AMENDMENTS TO THE DRAWINGS

Application No.: 10/734572

Docket No.: 53807-00066USPT

FIG. 7
(PRIOR ART)

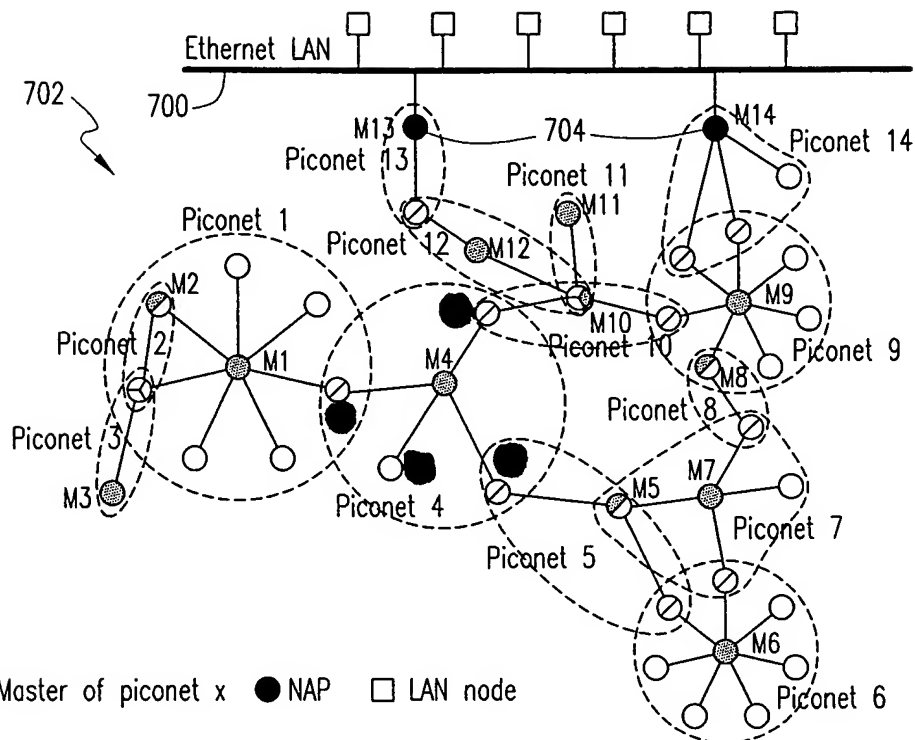
Figure 7 of the drawings is hereby amended to add the reference labels "S1," "S2," "S3," and "S4" to the four nodes directly connected to node "M4." Support for the amendment may be found in the specification in the paragraph bridging pages 31 and 32.
